Dubbo Project MOD1

Submissions Report

State Significant
Development 5251

August 2022

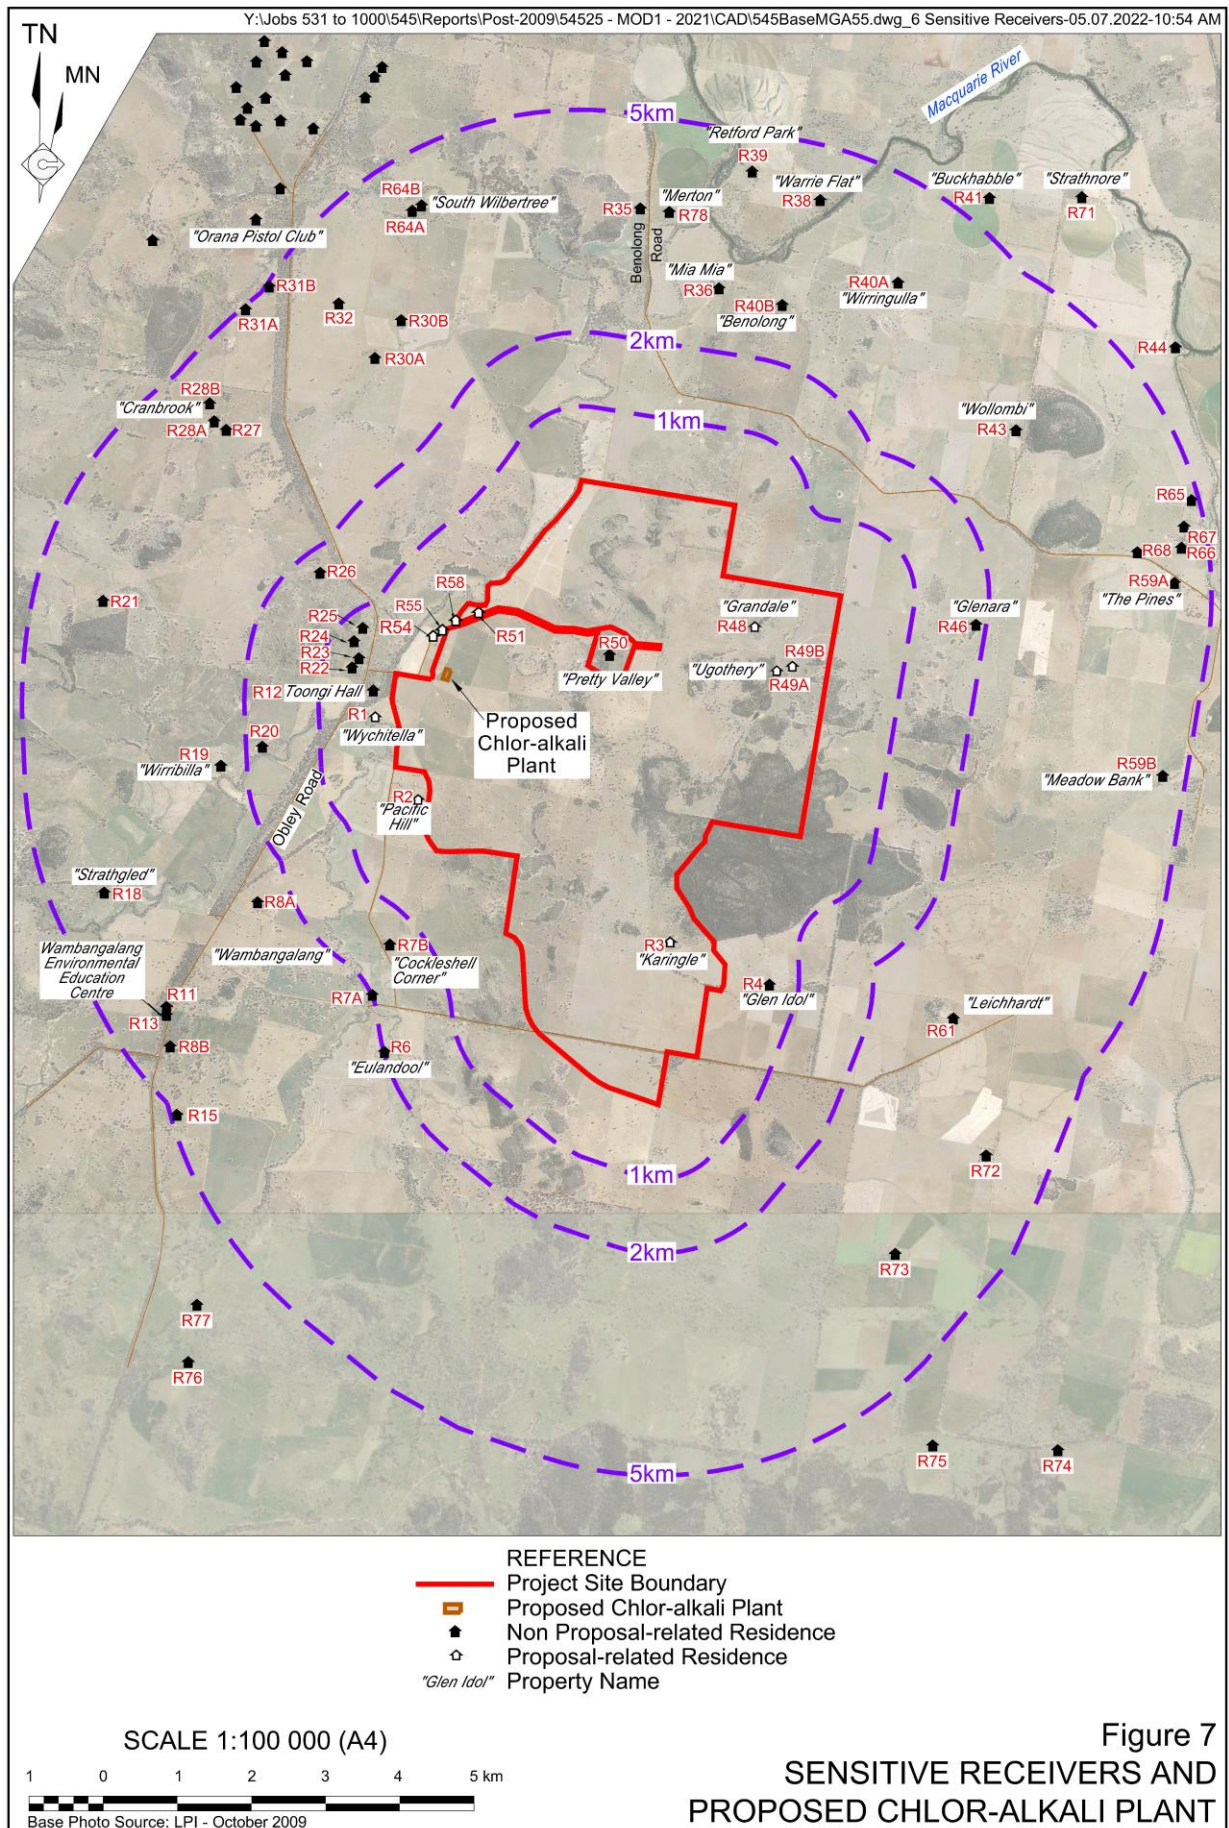
Besides Dubbo township, please clarify the closest residence located near the site boundary, in particular on the western side of the proposed Chlor-alkali plant.

Sensitive receivers in the vicinity of the Project Site are shown on **Figure 7** (Figure 6 in the *Modification Report*). **Table 2** lists both the minimum distance between each receiver and the Project Site boundary and the minimum distance between each receiver and the proposed Chlor-alkali Plant. As shown on **Figure 7** and in **Table 2**, the closest non Project-related sensitive receiver to the Project Site boundary is R50 (residential) (250m), the closest sensitive receiver to the proposed Chlor-alkali Plant is R12 (Toongi Hall) (1 003m), and the closest residential sensitive receiver to the proposed Chlor-alkali Plant is R23 (1 181m).

Figure 1: Project Site and Rail Corridor

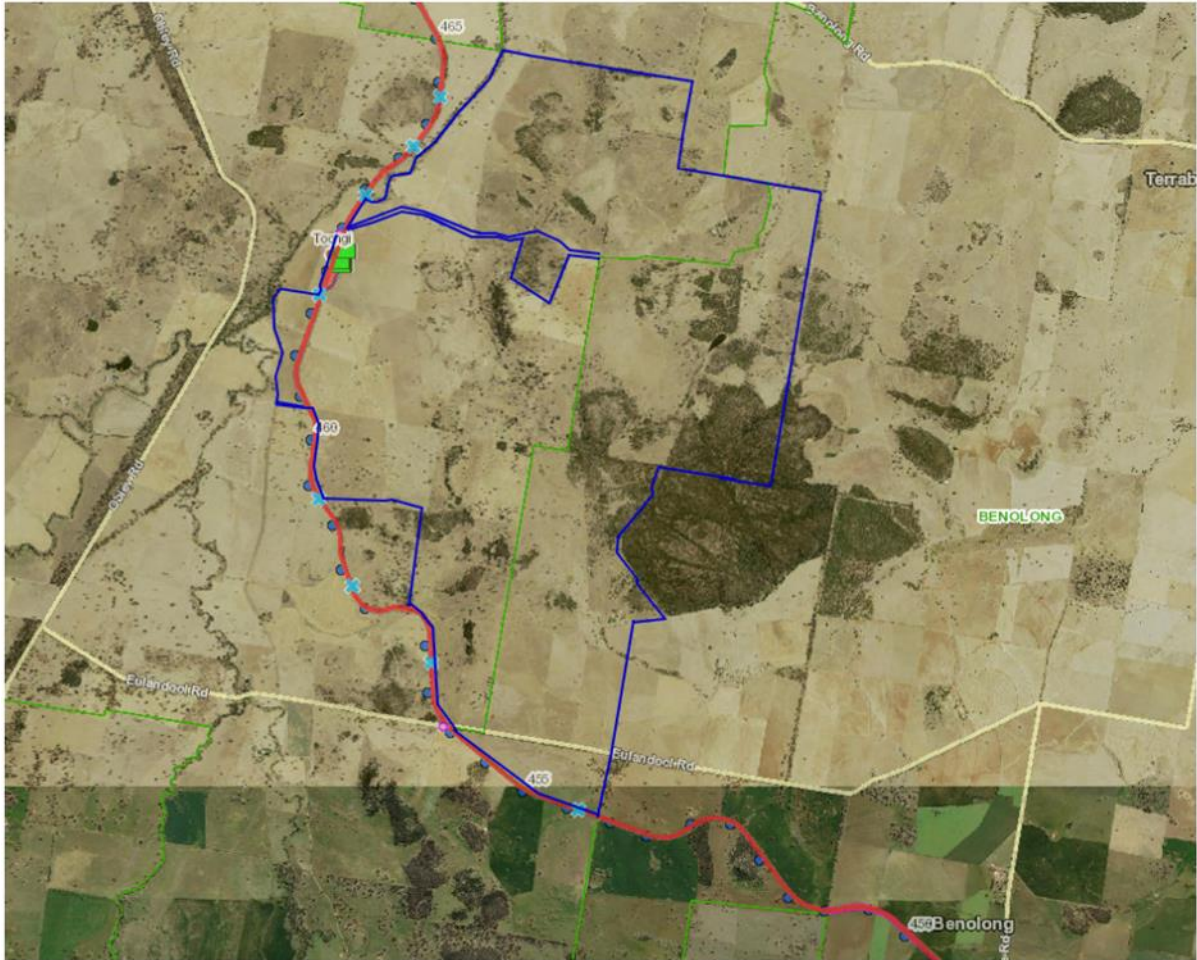
The proposal seeks constructions works for a processing plant, administration area, construction of Chlor-alkali plant, the rail container Laydown and storage area, which appears to involve the penetration of ground. No further design details are provided to address Section 2.98 of the State Environmental Planning Policy (SEPP) (Transport and Infrastructure) 2021 (previously Clause 86 of the ISEPP 2007) to confirm if there will be excavation greater than 2m in depth within 25m of the rail corridor.

The Applicant is requested to address the matters outlined in Section 2.98 of the SEPP (Transport and Infrastructure) 2021 applies. If the matters are relevant, the Applicant will need to contact TfNSW to ascertain the documentation requirements that will need to be addressed as part of the response to submissions.

The modification application seeks approval for construction and operation of a range of additional plant, the relocation and realignment of a range of approved Project components, an increase on the approved reagent transportation rate and an extension of the life of the project on the Land (delineated in blue in Figure 1) which is within and immediately adjacent to the non-operational rail corridor from Dubbo to Molong.

The Proposed Modification, including the construction of infrastructure in the vicinity of the Dubbo - Molong railway line, would not involve excavation or the penetration of the ground to a depth exceeding 2m within 25m of the railway corridor. As such, Section 2.98 of *State Environmental Planning Policy (Transport and Infrastructure) 2021* is not relevant to the Proposed Modification.
